AGENDA

PLANNING AND ZONING COMMISSION WORK SESSION MEETING
CITY HALL, 385 SOUTH GOLIAD STREET, ROCKWALL, TEXAS
NOVEMBER 1, 2023 IN THE CITY COUNCIL CHAMBERS AT 6:00 PM

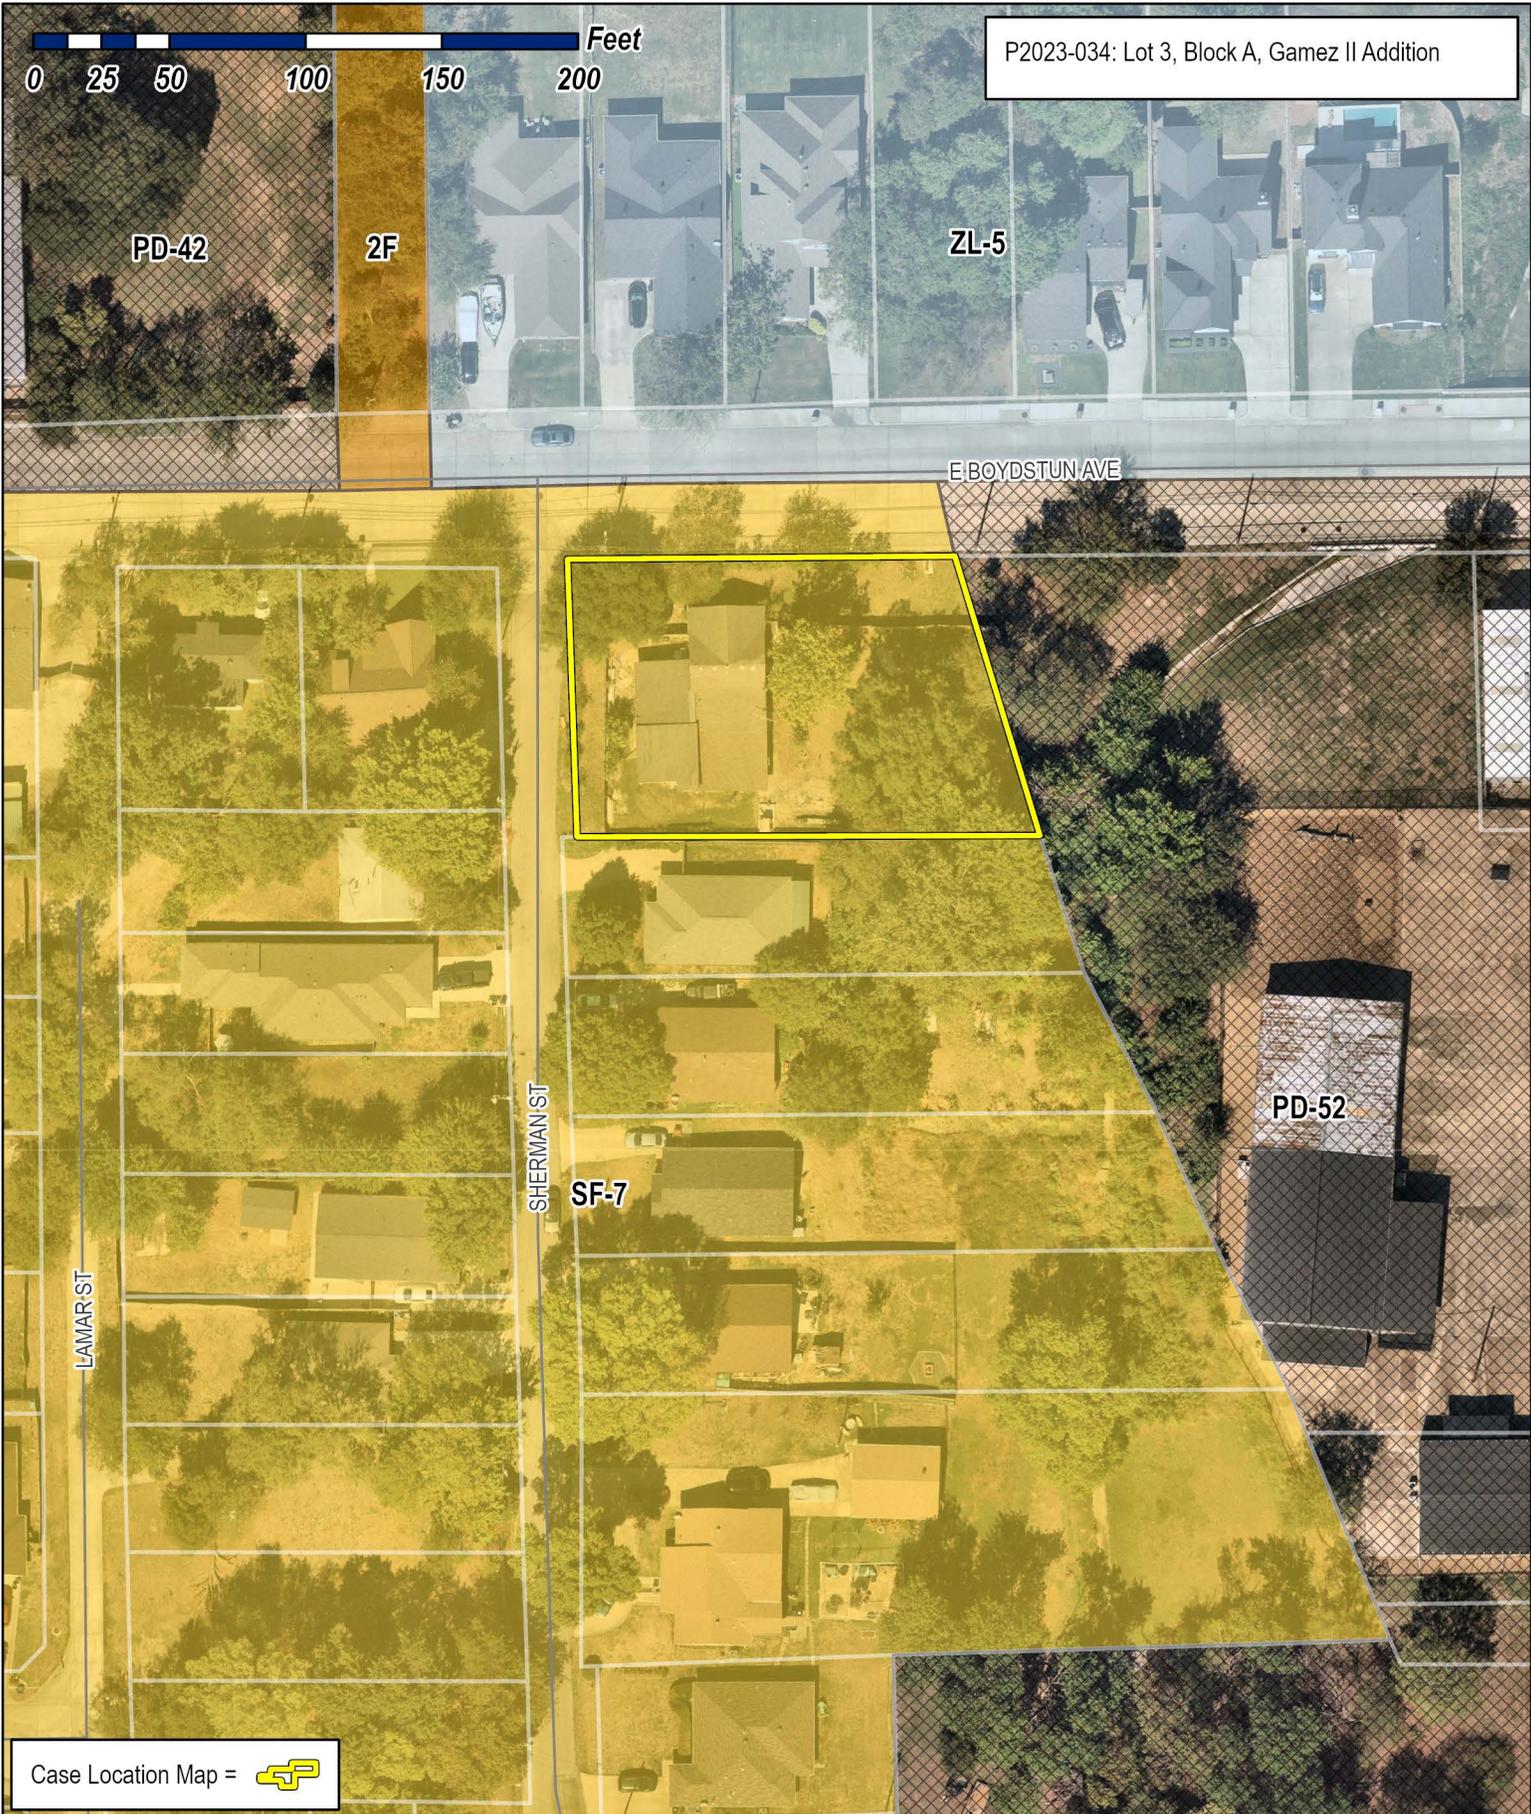
I HEREBY CERTIFY THAT I AM THE OWNER FOR THE PURPOSE OF THIS APPLICATION; ALL INFORMATION SUBMITTED HEREIN IS TRUE AND CORRECT; AND THE APPLICATION FEE OF \$ 10. TO COVER THE COST OF THIS APPLICATION, HAS BEEN PAID TO THE CITY OF ROCKWALL ON THIS THE 16th DAY OF October, 2023. BY SIGNING THIS APPLICATION, I AGREE THAT THE CITY OF ROCKWALL (I.E. "CITY") IS AUTHORIZED AND PERMITTED TO PROVIDE INFORMATION CONTAINED WITHIN THIS APPLICATION TO THE PUBLIC. THE CITY IS ALSO AUTHORIZED AND PERMITTED TO REPRODUCE ANY COPYRIGHTED INFORMATION SUBMITTED IN CONJUNCTION WITH THIS APPLICATION, IF SUCH REPRODUCTION IS ASSOCIATED OR IN RESPONSE TO A REQUEST FOR INFORMATION.
